Access Compliance Report

Public Rights-of-Way

Intersection ID: 8120	Main Street: INGLE_ST	Cross Street: TENNESSEE_AV	Location: N
ADA ID: 1A3570A07918	Ramp Type: BlendTrans2	Initial Pass/Fail: Pass	Overall Compliance: No
			Severity Score: 20.25

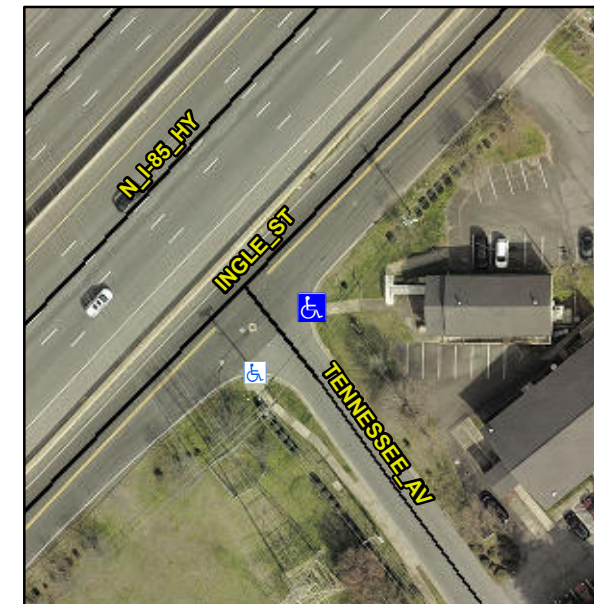
Not Found, R304.5.3, R305.2, R302.7.2, R304.5.4

Compliance	Description	Data	Compliance	Description	Data
N/A	Ramp Length (in)	67.0	Yes	BlendTrans Slope (%)	4.8
Yes	Ramp Width (in)	52.0	No	BlendTrans XSlope (%)	2.2
N/A	Flare Type LT	Sloped	N/A	Flare Type RT	Sloped
N/A	Flare Slope LT (%)	7.8	N/A	Flare Slope RT (%)	4.6
N/A	Flare Traversable LT?	No	N/A	Flare Traversable RT?	No
N/A	Landing Length (in)	N/A	Yes	DWS Provided?	Yes
N/A	Landing Width (in)	N/A	Yes	DWS Contrast?	Yes
N/A	Landing Slope (%)	N/A	Yes	DWS Length (in)	24.0
N/A	Landing X Slope (%)	N/A	Yes	DWS Full Width?	Yes
N/A	Landing Curb? (Y/N)	No	No	DWS Offset (in)	5.0
N/A	Shared Landing?	No			
Yes	Gutter Ponding?	No	No	Gutter Slope (%)	6.2
No	Gutter Lip Ht (in)	1.0	No	Gutter X Slope (%)	2.8
N/A	Painted X Walk1?	No	N/A	Painted X Walk2?	N/A
	X Walk 1 Direction	To SW		X Walk 2 Direction	N/A
	X Walk 1 Width (in)	N/A		X Walk 2 Width (in)	N/A
	X Walk 1 Slope (%)	0.1		X Walk 2 Slope (%)	N/A
	X Walk 1 X Slope (%)	3.6		X Walk 2 X Slope (%)	N/A

N/A	Ramp inside XWalk1?	N/A	N/A	Ramp inside XWalk2?	N/A
	Road Slope (%)	3.6		Clear Space?	Yes
	Road X Slope (%)	0.1	N/A	Clear Space to XWalk (in)	N/A
Yes	Any Obstructions?	No	Yes	Storm Grate/Utility Hazard?	No
	Obstruction Type			Storm Grate/Utility Type	
			N/A		N/A
			Yes	Surface Condition? (G/P)	Good
			No	Curb Slope (%)	25.3

Remove & Replace Curb Ramp With Two New Directional Ramps or Equivalent. Remove & Replace Gutter.
